TABLE OF CHANGES FOR PLANNING
AMMENDMENTS: PLAN

Project Title
T2 VITA LIVING, ST. JOHNS

Drawing Title
TYPICAL LEVEL 08 GA PLAN

Drawing Number
6555-P-B500-P-TYP-002 C

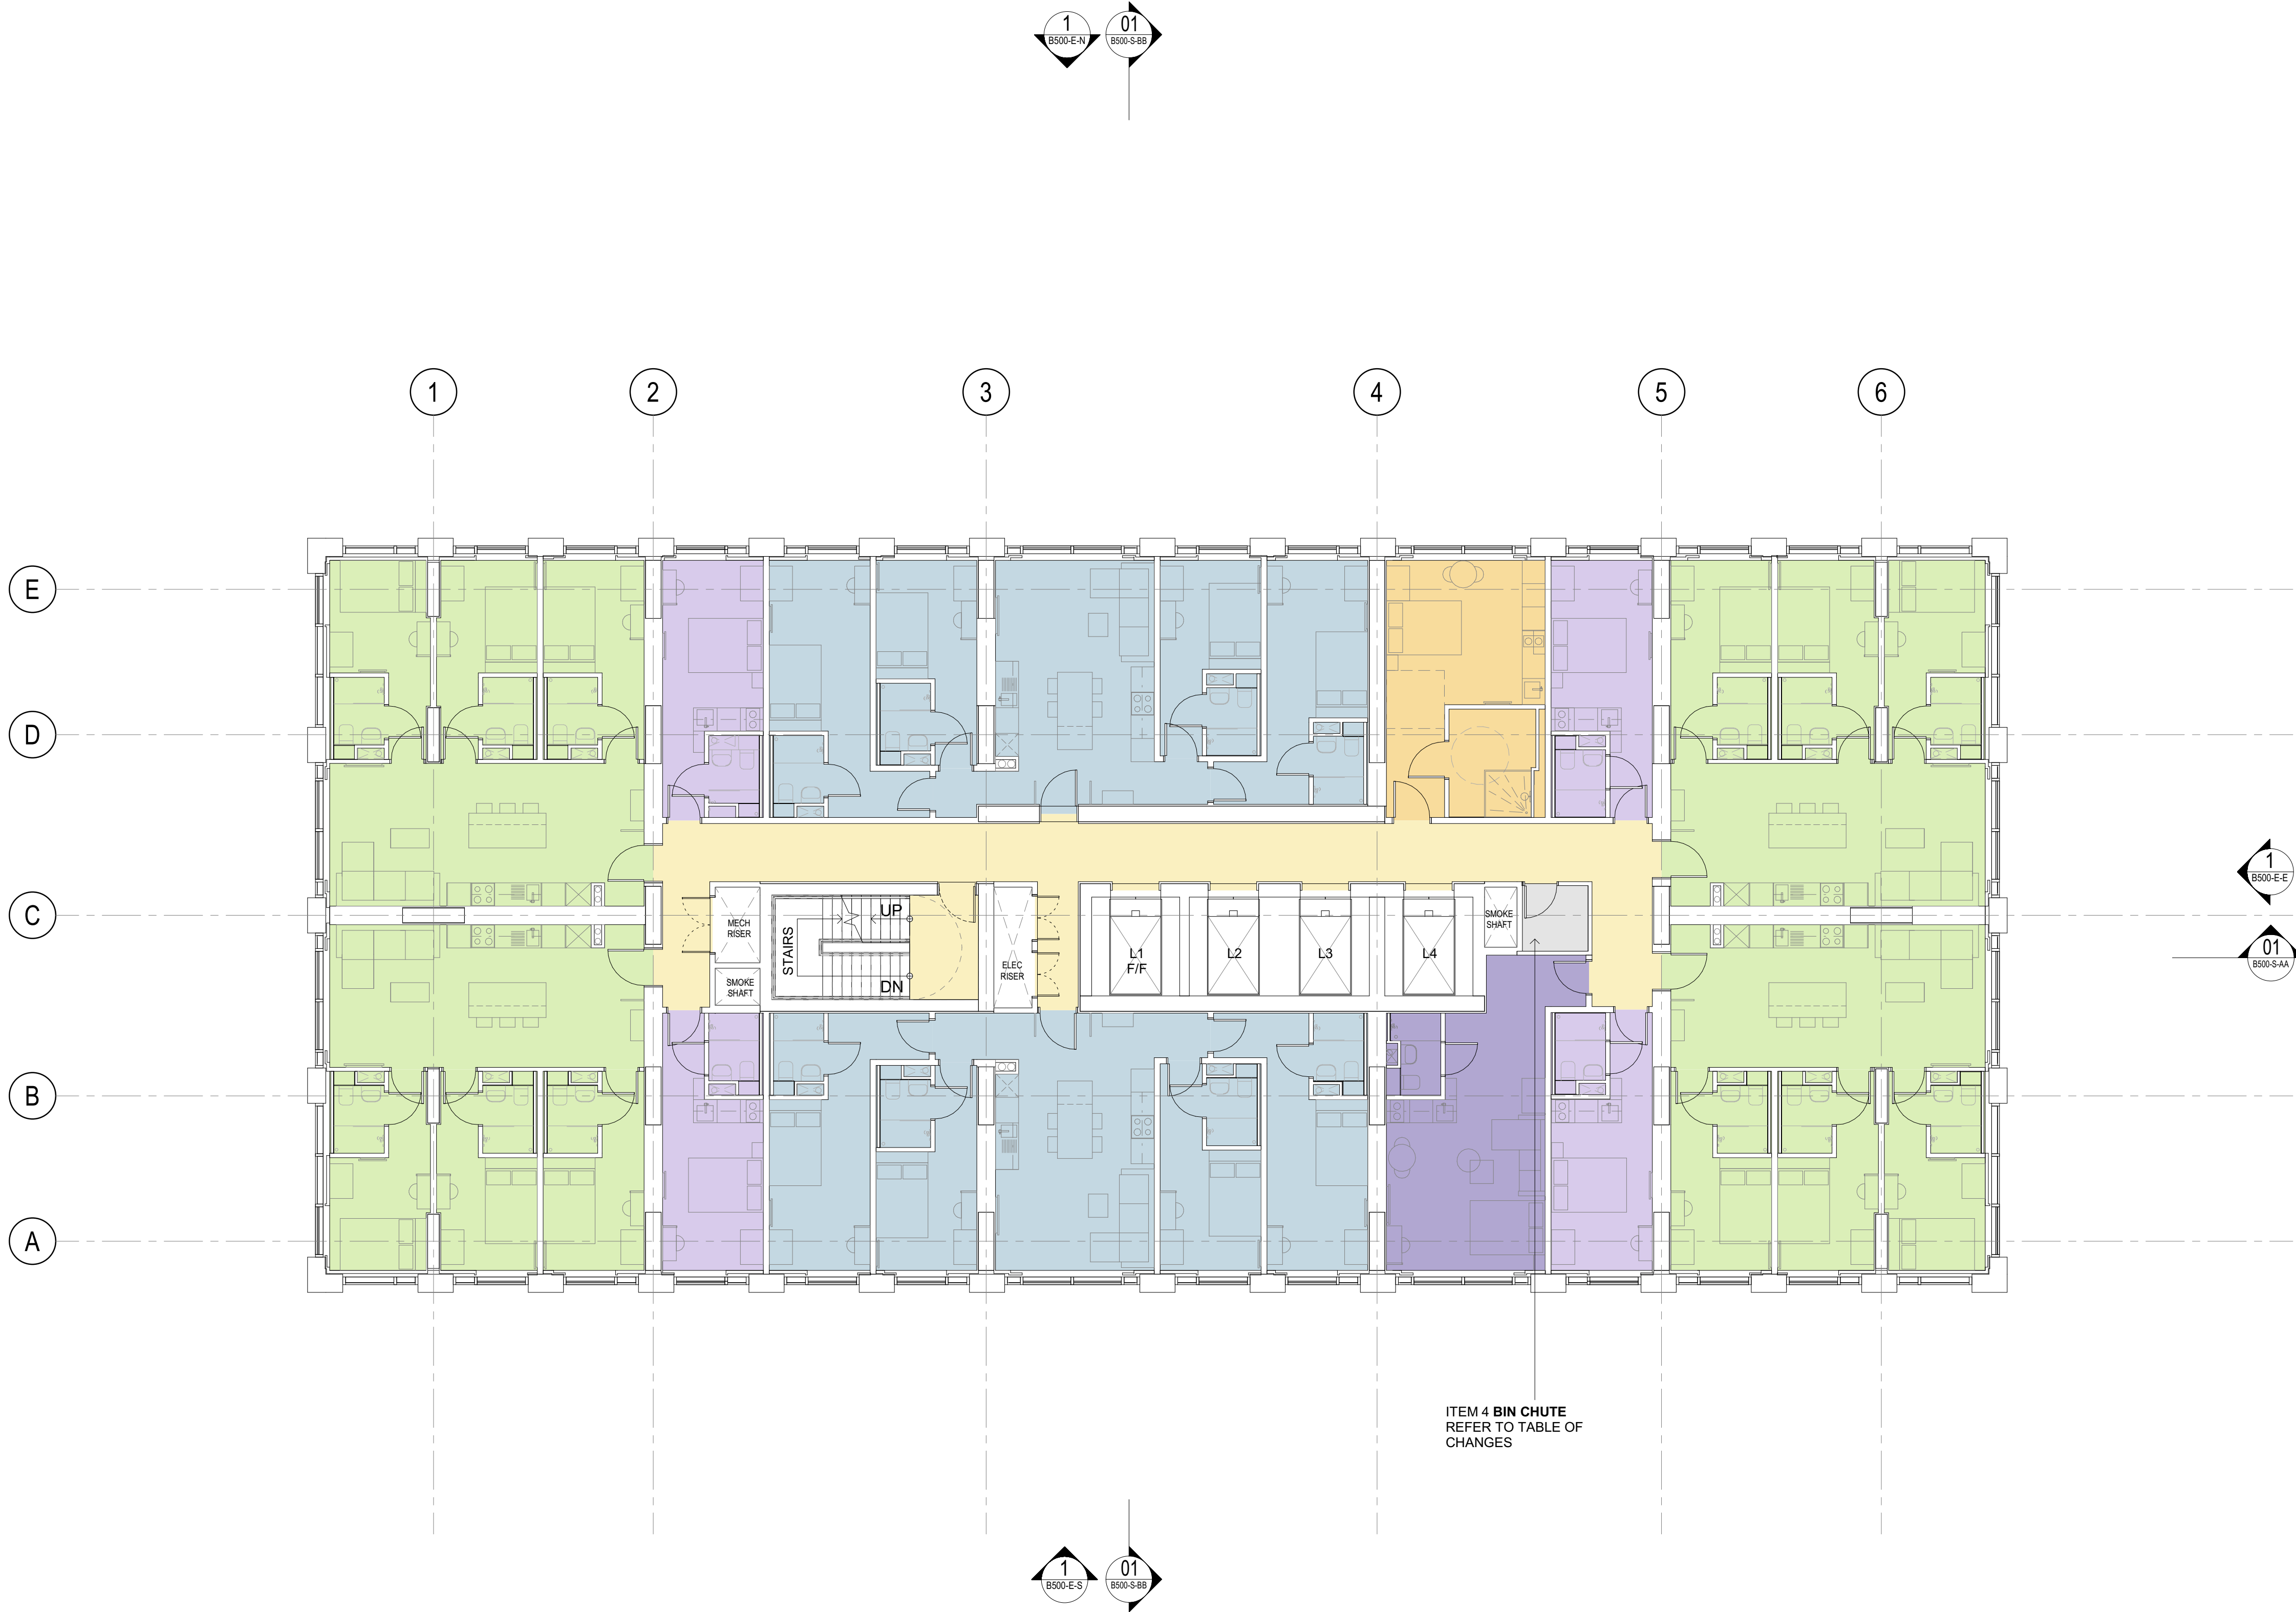
ITEM 4 BIN CHUTE
REFER TO TABLE OF
CHANGES
